AIR - NACELLE - EXHAUST - ACAC EXHAUST DUCT - EXIT AREA INCREASE OF - CATEGORY CODE 4
- MOD.NAC-75-0062

V2500-NAC-75-0062

SERVICE BULLETIN

**ACAC Duct Exit Area Modification
Figure 1**

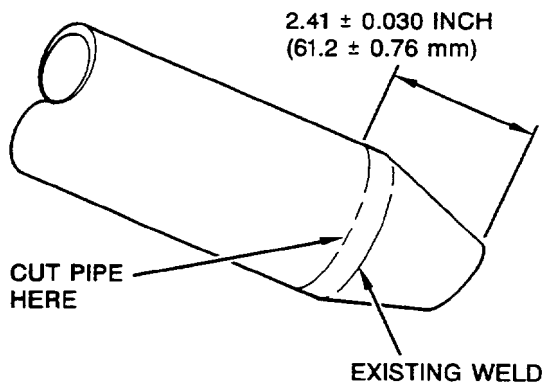
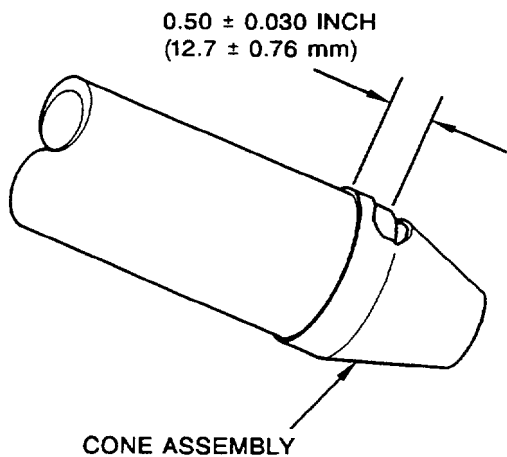
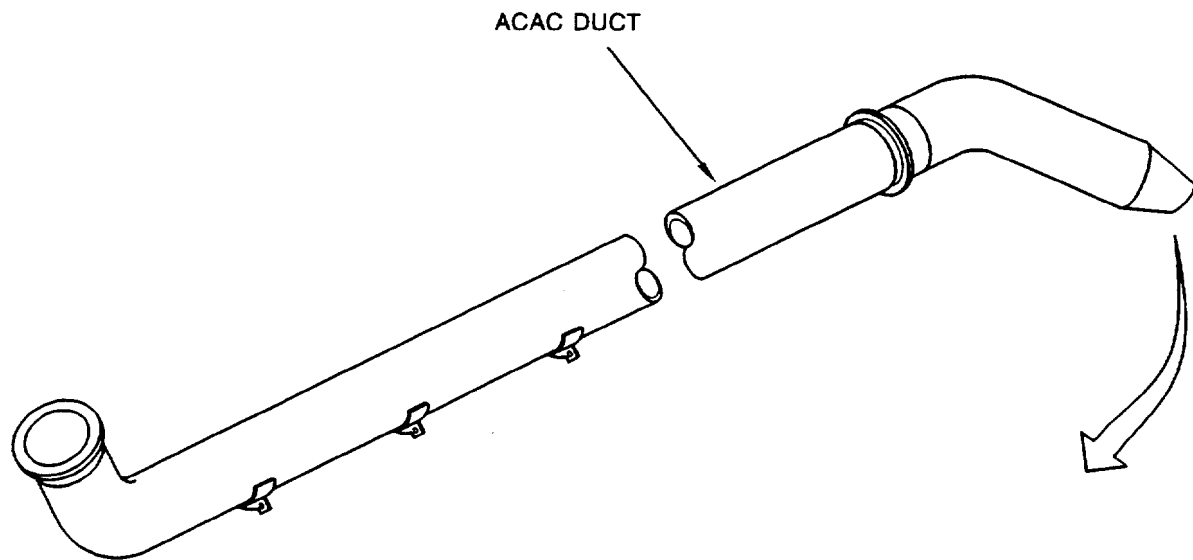
- (1) Remove the ACAC duct as instructed in the A320/A321 Aircraft Maintenance Manual, TASK 78-11-11-000-010.
- (2) Remove the exit end from the duct as shown in Figure 1. Remove all burrs and sharp edges.
- (3) Size the end of the tube.
- (4) Weld the 740-0364-2D cone assembly on the duct as shown in Figure 1. Refer to the IAE V2500 Standard Practices/Processes Manual, TASK 70-31-13-310-501. (MIL-STD-2219 is an acceptable substitute for TASK 70-31-13-310-501.) Use welding filler wire (CoMat 03-287).
- (5) Penetrant inspect the weld. Refer to the IAE V2500 Standard Practices/Processes Manual, TASK 70-23-00-230-501. (MIL-STD-6866 is an acceptable substitute for TASK 70-23-00-230-501.)

- (6) Identify the modified 740-0361-503 duct as the 740-0361-507 duct with electroetch or vibroetch method. Refer to the IAE V2500 Standard Practices/Processes Manual, Chapter 70-09-00.
- (7) Install the 740-0361-507 ACAC duct as instructed in the A320/A321 Aircraft Maintenance Manual, TASK 78-11-11-400-010.
